28. (PUD-1976) Application by Kelly J and Ian J Smith to rezone 10807 SW 29th Street from AA Agricultural District to PUD-1976 Planned Unit Development District. Ward 3.

**STAFF REPORT**  
**The City of Oklahoma City**  
**Planning Commission**  
**December 14, 2023**

**Item No. IV. 28.**

**(PUD-1976) Application by Kelly J and Ian J Smith to rezone 10807 SW 29th Street from AA Agricultural District to PUD-1976 Planned Unit Development District. Ward 3.**

Exhibit B  
Conceptual Master Development Plan

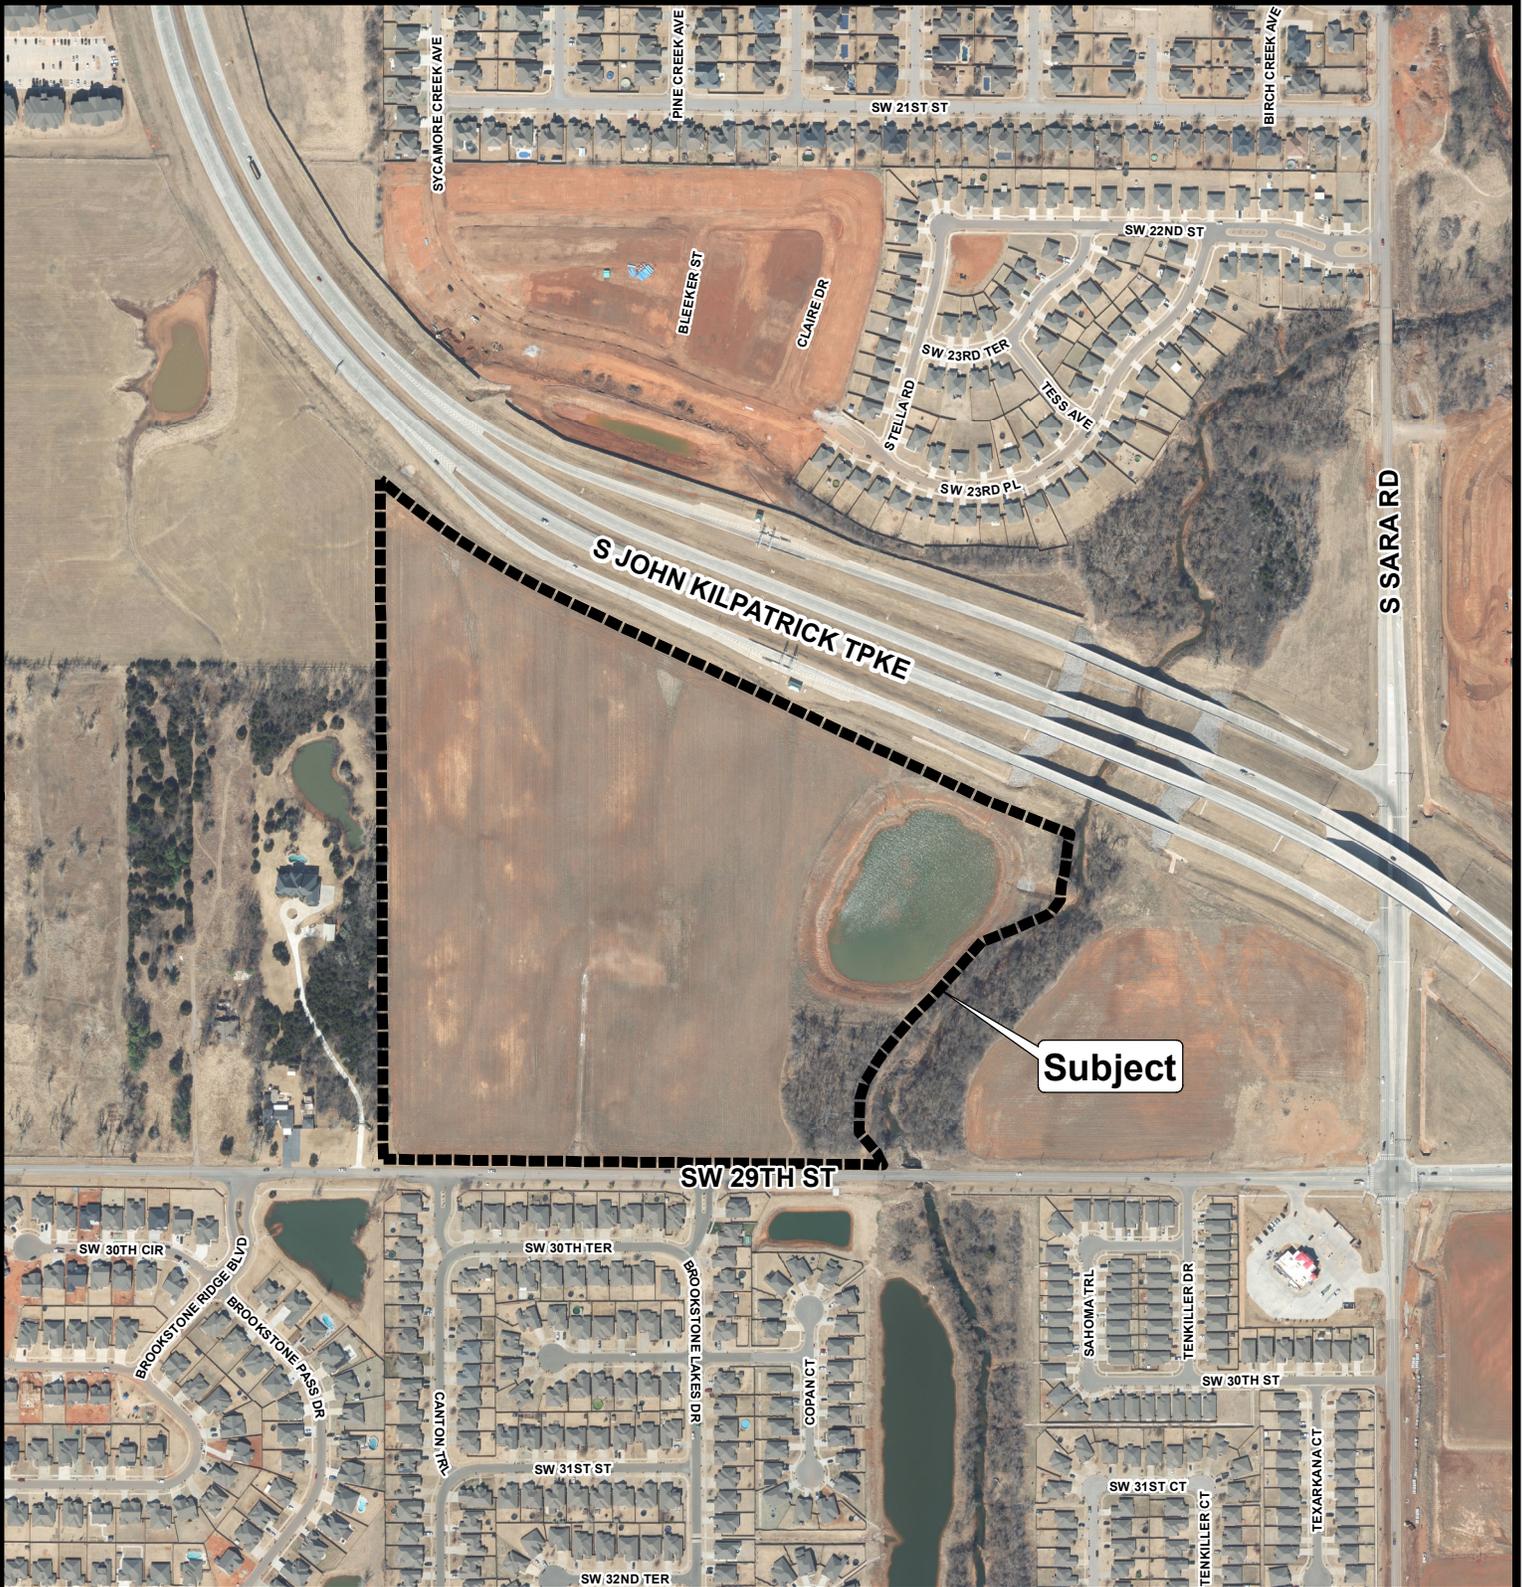
3. Amend the Master Design Statement to require a minimum amount of open space commensurate with what is shown on the conceptual plan, and increase the amount of open space provided in the northwest portion of the subdivision.

*Access is proposed via up to three points along SW 29<sup>th</sup> Street. A street stub is shown west and would be required per the Subdivision Regulations. The PUD states no connections shall be required to the east or the north given physical constraints. This would require a variance at the time of platting.*

Plan conformance would be strengthened by requiring a minimum amount of open space commensurate with the conceptual plan, providing additional open space that is accessible to lots on the northwest portion of the subdivision, and providing a landscape buffer or larger lots along the west boundary of the PUD where adjacent to PUD-1185. If 30-foot lots are approved, driveways should be limited to 12 feet in width with single car garages to limit the amount of paved surface and allow space for front yard trees. Additional on-street parking may be necessary. If other than on-street parallel parking is provided, the PUD should specify that maneuvering in the right-of-way is allowed, but parking is subject to necessary approvals, including from Traffic & Transportation Commission and City Council, if required.

1. Modify front setback to specify *garages* shall be located no less than 18 feet from the back of the sidewalk.
2. Lot size and lot width is per dwelling unit.

6. The Master Design Statement shall be amended to the one dated December 13, 2023, except that the minimum lot width shall be 40 feet and minimum lot size shall be 4,000 square feet.
